N6775A-01

S E R V I C E N O T E

N6775A 300W DC Power Module

Current Measurement accuracy is out of specification when there is voltage being sourced at the output terminals.

Location of C36 and C37

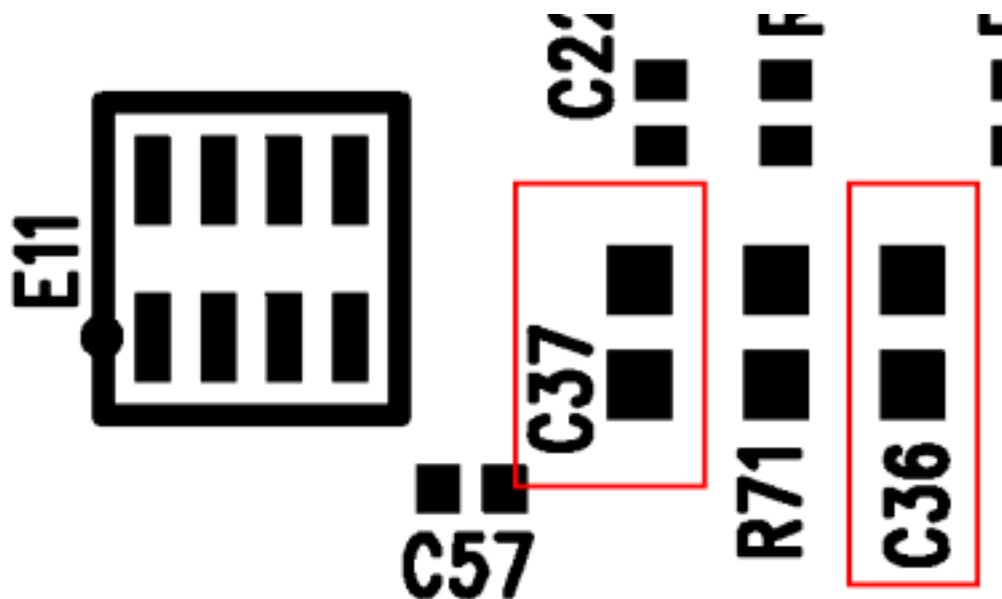
Due to some noise filtering issues, the current measurement accuracy will be out of specification by a fixed offset when there is a voltage being sourced at the output terminals. If the output is shorted, the current measurement accuracy will be within specifications. Please note that the performance verification test will not catch this.

If this measurement is out of specification, replace capacitors C36 and C37 on the DPM assembly (this is the assembly that is vertically mounted in the unit that looks similar to a PC memory module) with part number 0160-7809. After the capacitors are changed, the unit will require re-calibration. After the capacitors are replaced, check the make sure that the unit is in specification by applying 75% of the full voltage range while attached to a load drawing 50 mA to 70 mA. If the current measurement is within the specification, then the unit has been repaired.
